Reference: Block 39 – Youngblood Subdivision, Elora, ON
Arborist Report – Rev1: As per Township Comments

**Reference: Block 39 – Youngblood Subdivision, Elora, ON
Arborist Report**

OWNER: Granite Homes South River Inc.
LOCATION: Township of Centre Wellington
PROJECT: 250 Harrison Street, Elora
 Youngblood Subdivision, Block 39

DRAWING: Grading Plan
DESIGNED BY: AWB
CHECKED BY: CHT
DATE: Dec 7, 2022
CONTRACT: M230216
FILE NAME: 5058
DRAWING: 5058-4
SCALE: 1:300
SHEET: 4 of 6

Markup By JK Consulting Arborists

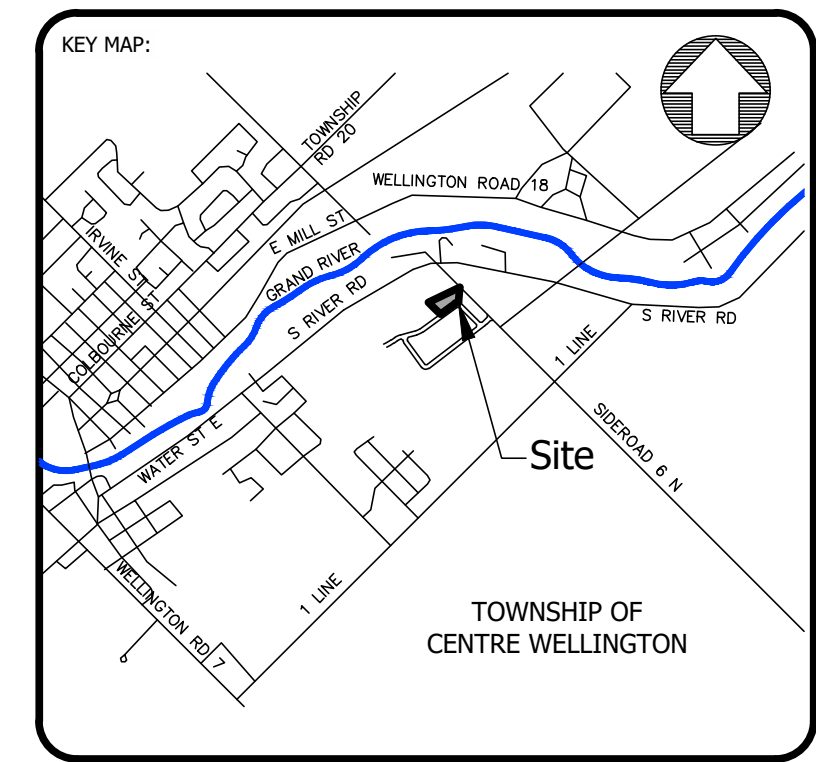
The location of the property line was estimated in the field using the locations of existing trees identified on the Grading Plan. The trees on 23 Gilkison Street were predominantly located 1m off the property line, except for a large sugar maple (*Acer saccharum*). The sugar maple, growing adjacent to the northeast corner of Block 39, was located adjacent to the property line according to the legal survey. This tree was in good condition. This tree has been labeled on a draft Grading Plan, see attached.

A meeting with the Project team was held to discuss the current grading and construction in relation to trees on adjacent property. JK Consulting Arborists recommended a minimal two metre setback from the property line, as this would mitigate impacts to trees on adjacent property, and smaller trees located on the property line. The two-metre setback would allow a <40% or less encroachment into the tree's dripline, thus not compromising the health or structural integrity of the neighboring trees. Trees already in poor condition or dead would continue to naturally decline or fail. Meritech reviewed the setback recommendation and provided a revised Draft Grading Plan (refer to the attached). The Draft Grading Plan identifies a setback of two metres from the property line along the northern boundary, except for the northeast corner. In the northeast corner of the Block, grading has been designed to achieve the drainage required for the Project. Meritech has revised the grading to be set back from the northern property line and from the Sugar Maple. The grading to facilitate the construction of the slope will encroach <40% into the dripline of the Sugar Maple. As indicated in the attached draft Grading Plan, the proposed TPF will be installed at the bottom of the slope.

The Grading Plan has been revised to include a two-metre setback to the north property line to protect the trees owned by the adjacent property owner, with the exception for the sugar maple located in the northeast corner. The setback from the property line adjacent to the Sugar Maple ranges from 1 metre to 5 metres. The overall encroachment for grading is less than 40% into the dripline of the Sugar Maple. Based on the encroachment into the dripline of trees located on adjacent property, it is believed that the health and condition of the trees will not be compromised. Tree Protection Fence recommendations as stated in this report shall be followed by the contractor.
